Document Action Request

Document No.: CP 3804M Rev. No.: 1 Chg. No.: 1

Title: PASS Ventilation Samples

Modified procedure and added Attachment 10 to reflect new collector assembly installed under DCN DM3-00-0258-99

Attachment 10
3HVQ-RE49 Filter Housing Configuration
(Sheet 1 of 1)

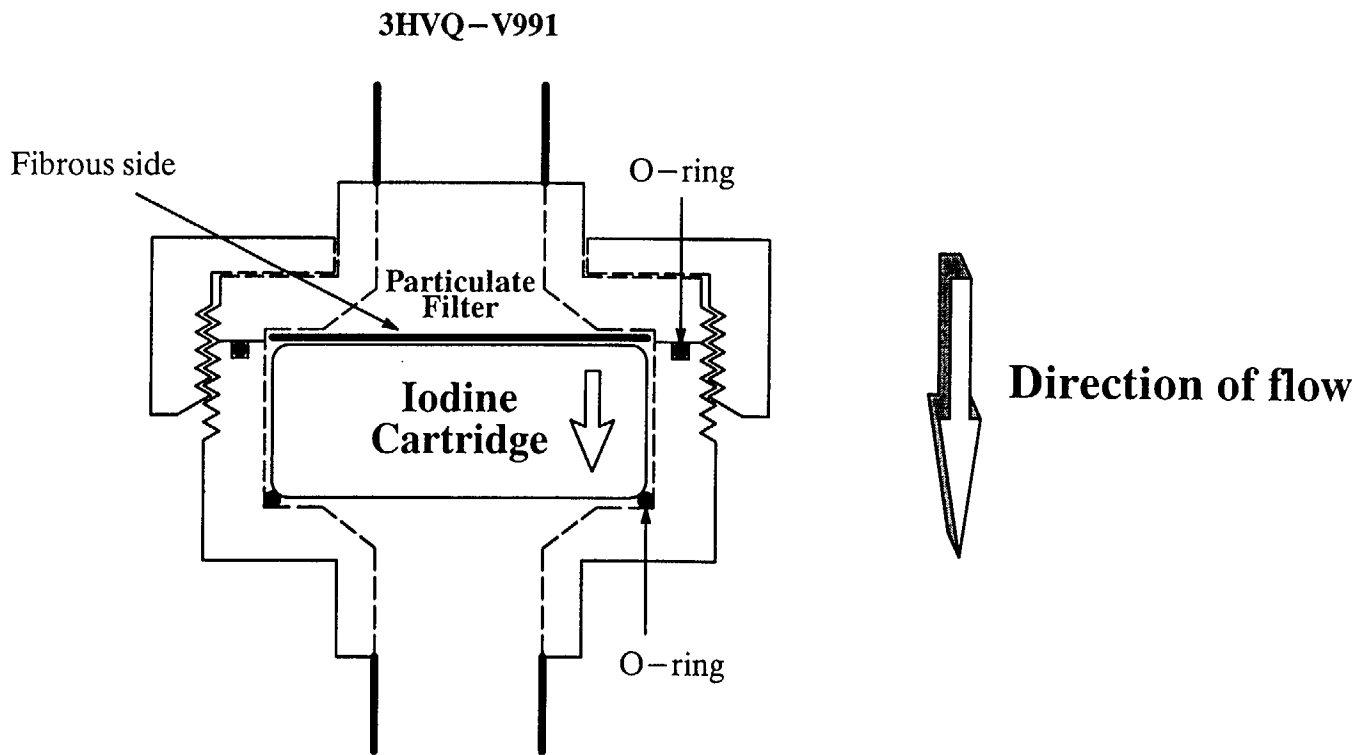
- Modified procedure and added Attachment 10 to reflect new collector assembly (iodine cartridge and particulate filter holder) installed under Reference 6.11.

4.7.8 Refer To Attachment 10 and PERFORM the following: ①

- a. INSPECT O-rings on HVQ 49 iodine-particulate sample holder.
- b. REPLACE O-rings as required.
- c. PLACE iodine cartridge and particulate filter into sample holder.
